# Application for Plan Review

Name of Project: Church at Anderson Creek

## Application for Plan Review

Church at Anderson Creek  
126 Archie Street  
Spring Lake, NC 28390

Second Floor Plan

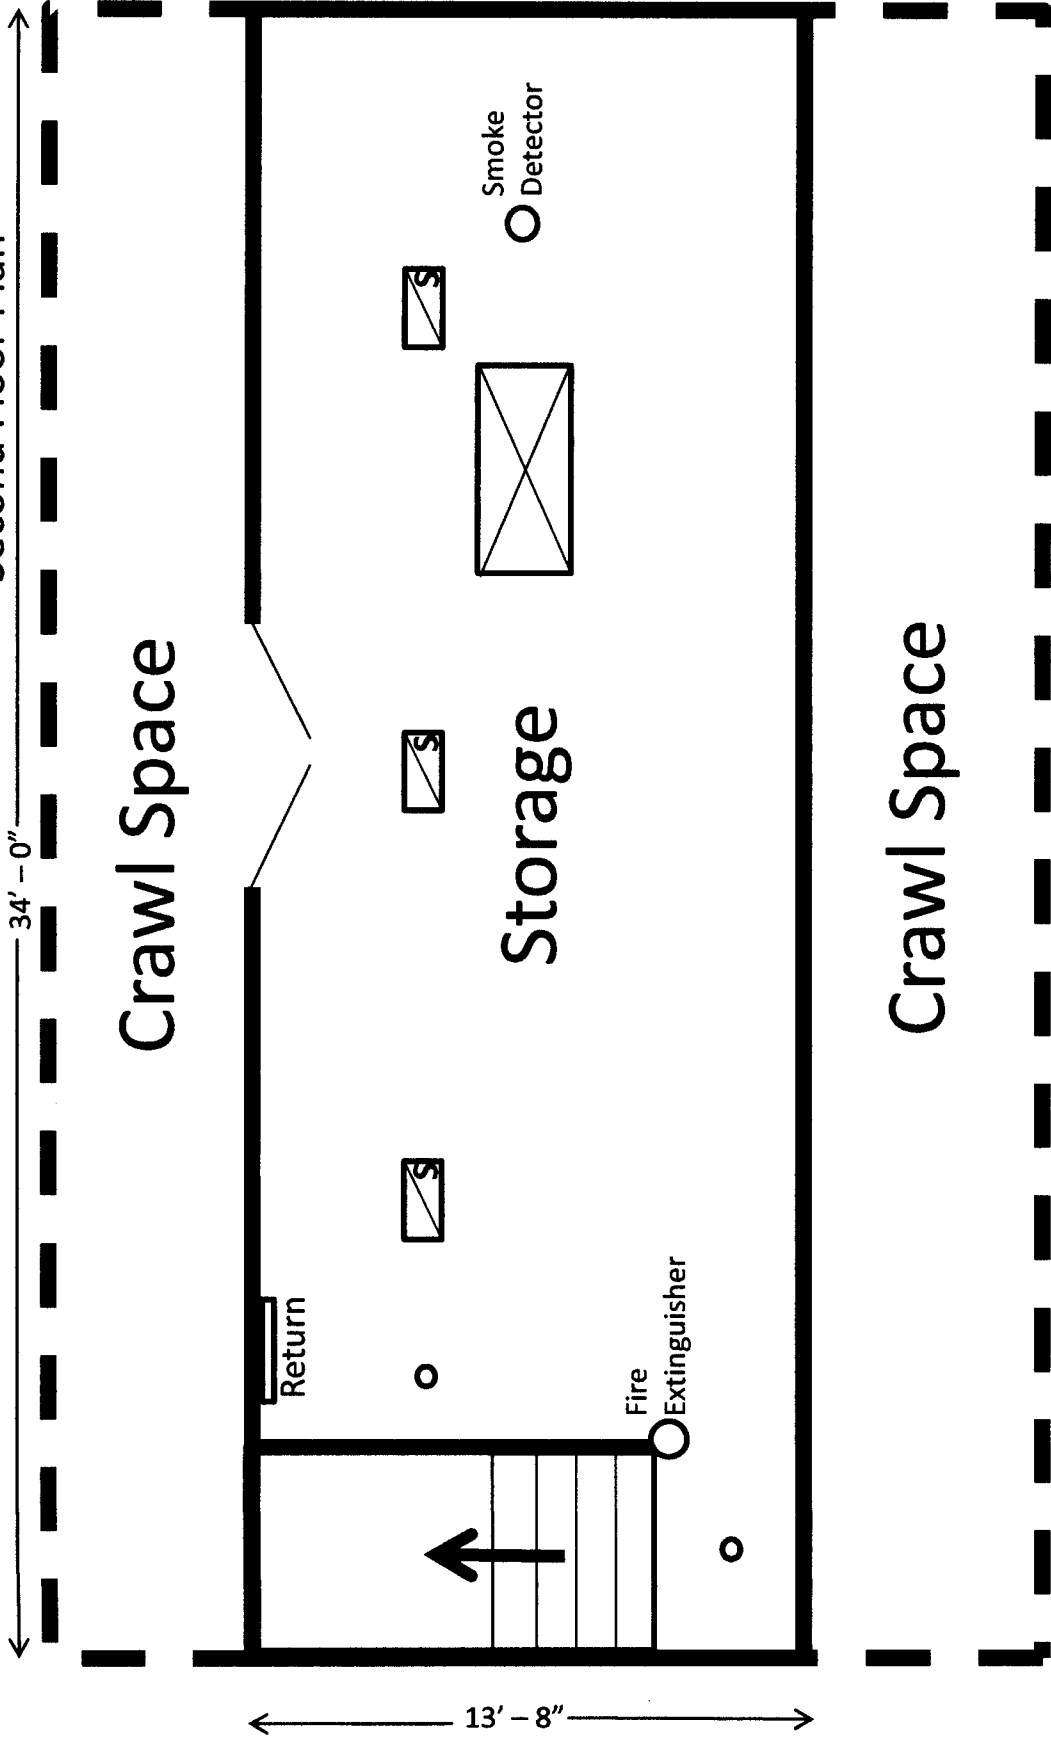
Fire Extinguisher

Smoke Detector
